LASALLE COUNTY STATION, UNIT 1

AMENDMENT TO FACILITY OPERATING LICENSE

Amendment No. 60  
License No. NPF-11

LASALLE COUNTY STATION, UNIT 2

Figure 3.4.1.5-1

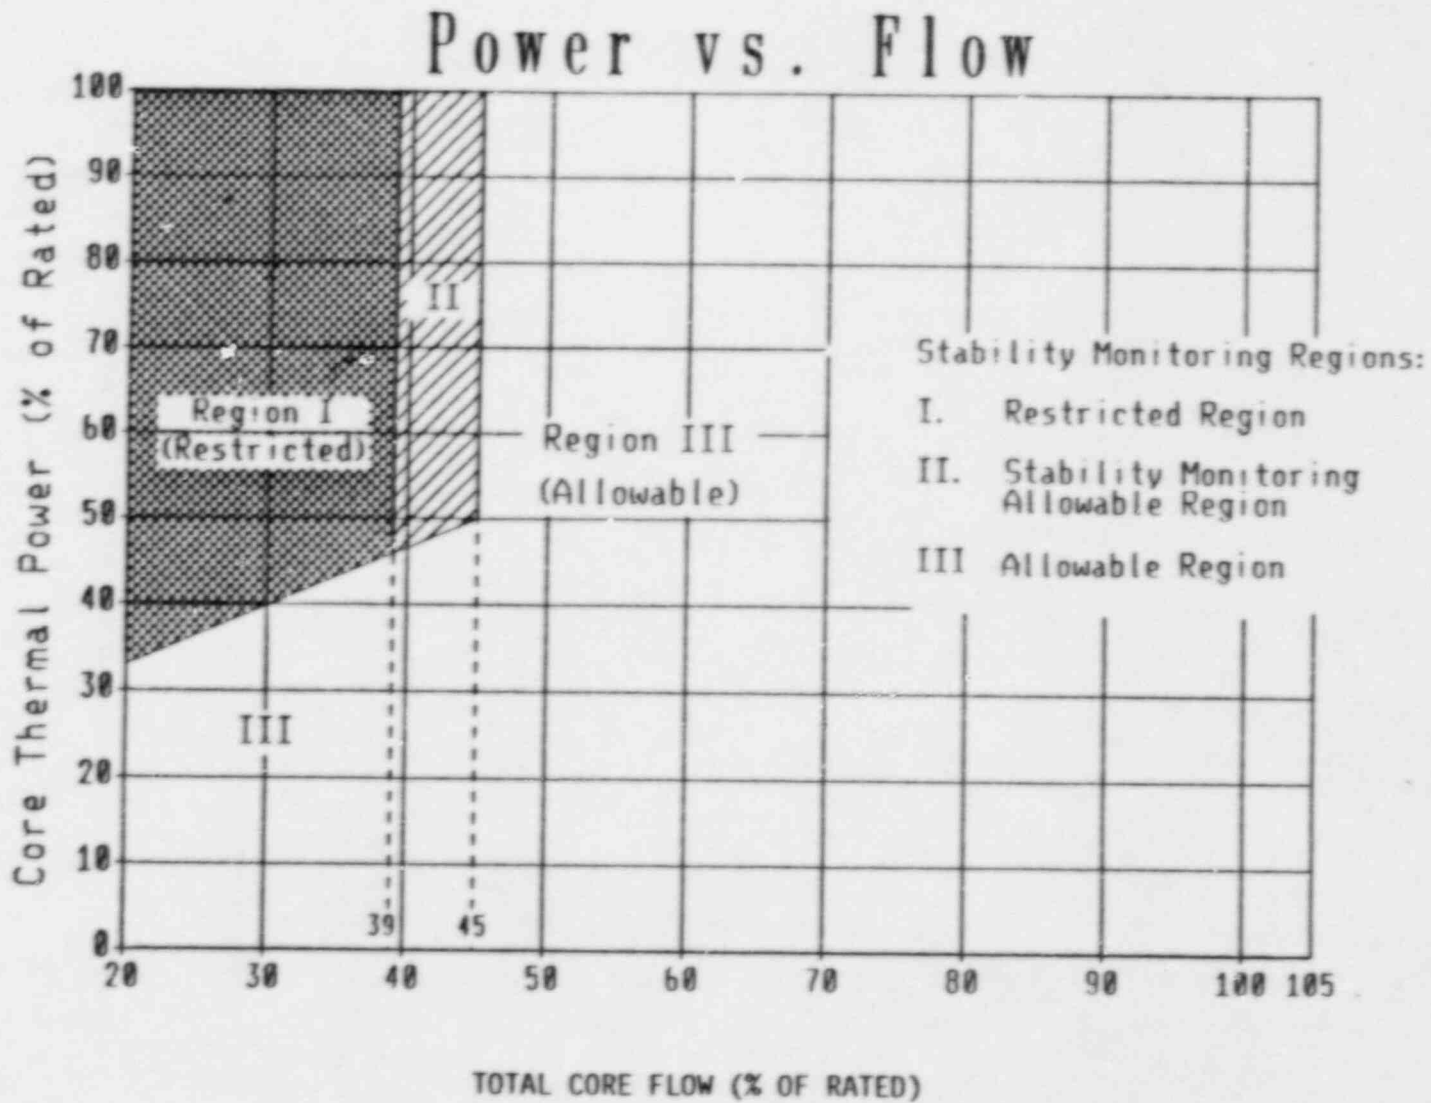
- a. Total core flow greater than or equal to 45% of rated core flow, or
- b. THERMAL POWER within Region III of Figure 3.4.1.5-1, or
- c. THERMAL POWER within Region II of Figure 3.4.1.5-1 AND APRM and LPRM noise levels not exceeding the larger of: i) Three (3) times the established baseline noise levels or, ii) 10% peak-to-peak indicated noise level.

- a. In Region I of Figure 3.4.1.5-1:
  1. With at least 1 reactor coolant recirculation loop in operation immediately initiate action to:
    - a) Decrease THERMAL POWER by control rod insertion, completing the power decrease within two (2) hours to exit Region I or,
    - b) Increase core flow with the operating Recirculation Loop(s), to exit Region I within two (2) hours.
  2. With no reactor coolant recirculation loops in operation:
    - a) Immediately reduce CORE THERMAL POWER by inserting control rods, observing the indicated APRM and LPRM noise levels, and complete power reduction to below 36% of RATED CORE THERMAL POWER within two (2) hours, and
    - b) If indicated LPRM or APRM noise levels exceed 10% peak-to-peak, immediately place the reactor mode switch in the SHUTDOWN position.
    - c) Comply with Specification 3.4.1.1 ACTION b.2

- b. In Region II of Figure 3.4.1.5-1, with APRM or LPRM neutron flux noise levels exceeding the larger of: i) Three (3) times the established baseline noise levels, or ii) 10% peak-to-peak noise indication.
  1. Immediately initiate corrective action by inserting control rods or increasing core flow to restore the noise levels to within the required limit within 2 hours, otherwise.
  2. Insert control rods to reduce THERMAL POWER and/or increase core flow to enter Region III of Figure 3.4.1.5-1 within the next 2 hours.

4.4.1.5 When operating within Region II of Figure 3.4.1.5-1, verify:

Region I of Figure 3.4.1.5-1 represents a region of the power/flow map where instability in neutron flux have been observed. Operation in this region is prohibited to ensure that stable reactor conditions are maintained. Actions to immediately exit Region I are intended to prevent lower priority (i.e., non-emergency) concerns from delaying exit from the region. Observation of neutron flux indications, while not requiring formal surveillance, is needed to avoid reliance on automatic protective systems. A manual reactor scram is required if instabilities are evidenced in Region I with no recirculation pumps operating.

Operation within a designated surveillance region (Region II of Figure 3.4.1.5-1) requires monitoring of APRM and LPRM noise levels. Observed instabilities require immediate corrective action due to the potential for increasing oscillations.

Figure 3.4.1.5-1

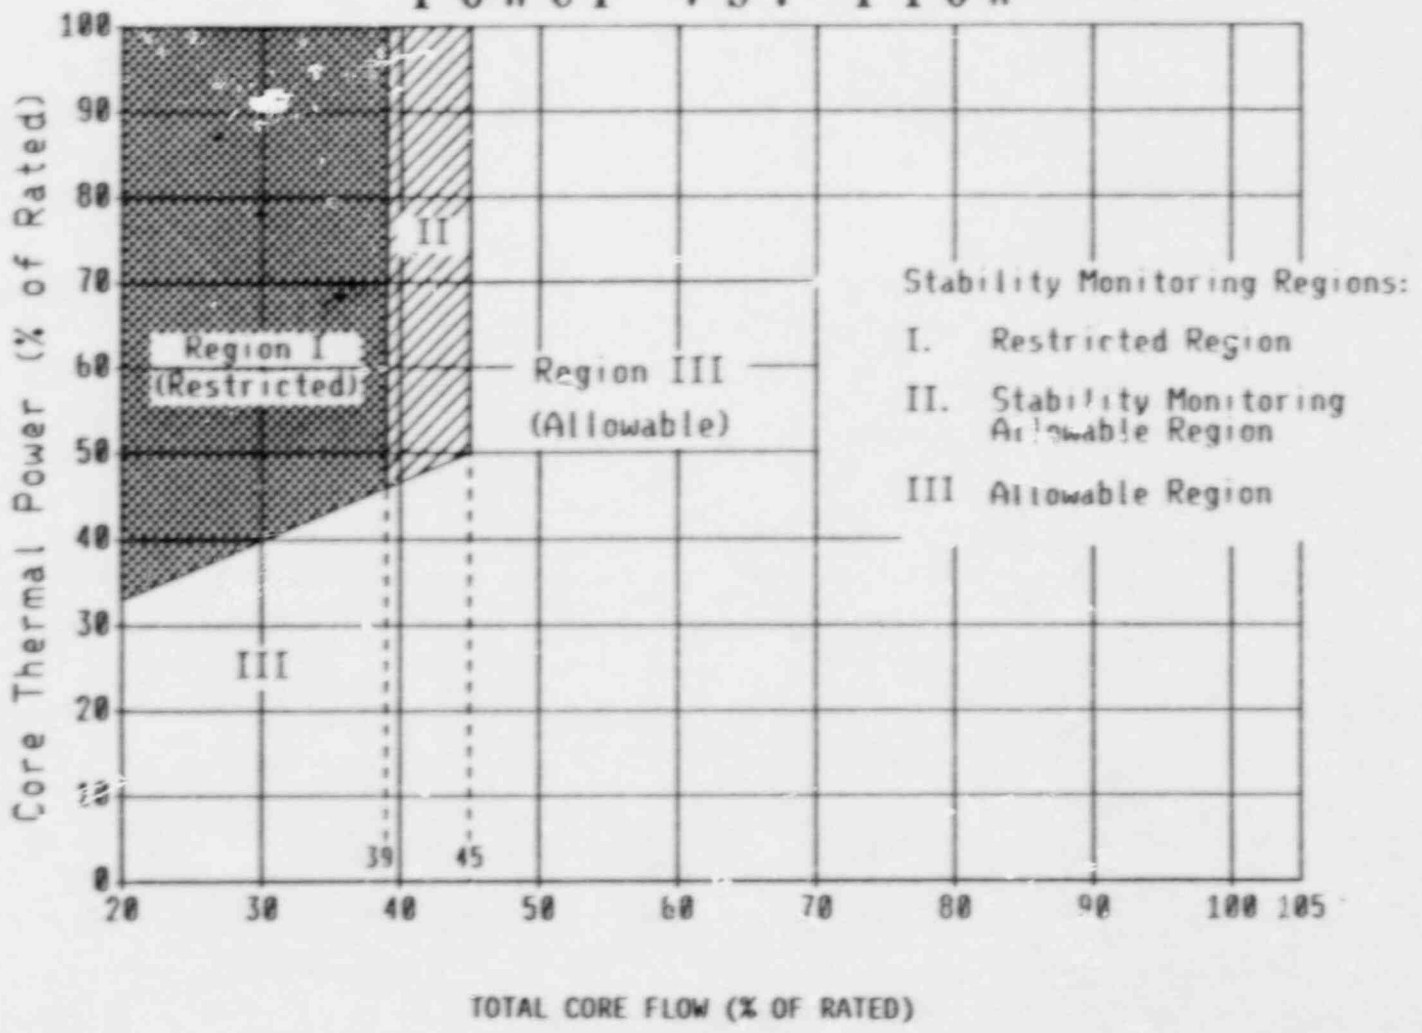
- a. Total core flow greater than or equal to 45% of rated core flow, or
- b. THERMAL POWER within Region III of Figure 3.4.1.5-1, or
- c. THERMAL POWER within Region II of Figure 3.4.1.5-1 AND APRM and LPRM noise levels not exceeding the larger of: i) Three (3) times the established baseline noise levels or, ii) 10% peak-to-peak indicated noise level.

- a. In Region I of Figure 3.4.1.5-1:
  1. With at least 1 reactor coolant recirculation loop in operation immediately initiate action to:
    - a) Decrease THERMAL POWER by control rod insertion, completing the power decrease within two (2) hours to exit Region I or,
    - b) Increase core flow with the operating Recirculation Loop(s), to exit Region I within two (2) hours.
  2. With no reactor coolant recirculation loops in operation:
    - a) Immediately reduce CORE THERMAL POWER by inserting control rods, observing the indicated APRM and LPRM noise levels, and complete power reduction to below 36% of RATED CORE THERMAL POWER within two (2) hours, and
    - b) If indicated LPRM or APRM noise levels exceed 10% peak-to-peak, immediately place the reactor mode switch in the SHUTDOWN position.
    - c) Comply with Specification 3.4.1.1 ACTION b.2

- b. In Region II of Figure 3.4.1.5-1, with APRM or LPRM neutron flux noise levels exceeding the larger of: i) Three (3) times the established baseline noise levels, or ii) 10% peak-to-peak noise indication.
  1. Immediately initiate corrective action by inserting control rods or increasing core flow to restore the noise levels to within the required limit within 2 hours, otherwise.
  2. Insert control rods to reduce THERMAL POWER and/or increase core flow to enter Region III of Figure 3.4.1.5-1 within the next 2 hours.

- 4.4.1.5 When operating within Region II of Figure 3.4.1.5-1, verify:
1. That the APRM and LPRM neutron flux noise levels do not exceed the larger of: i) Three (3) times the established baseline levels or, ii) 10% peak-to-peak indicated noise level:
    - a. At least once per 12 hours, and
    - b. Initiate the surveillance within 15 minutes after entering the region or completing an increase of at least 5% of RATED THERMAL POWER, completing the surveillance within the next 30 minutes.
  2. That core flow is greater than or equal to 39% of rated core flow at least once per 12 hours.

Region I of Figure 3.4.1.5-1 represents a region of the power/flow map where instability in neutron flux have been observed. Operation in this region is prohibited to ensure that stable reactor conditions are maintained. Actions to immediately exit Region I are intended to prevent lower priority (i.e., non-emergency) concerns from delaying exit from the region. Observation of neutron flux indications, while not requiring formal surveillance, is needed to avoid reliance on automatic protective systems. A manual reactor scram is required if instabilities are evidenced in Region I with no recirculation pumps operating.

Operation within a designated surveillance region (Region II of Figure 3.4.1.5-1) requires monitoring of APRM and LPRM noise levels. Observed instabilities require immediate corrective action due to the potential for increasing oscillations.
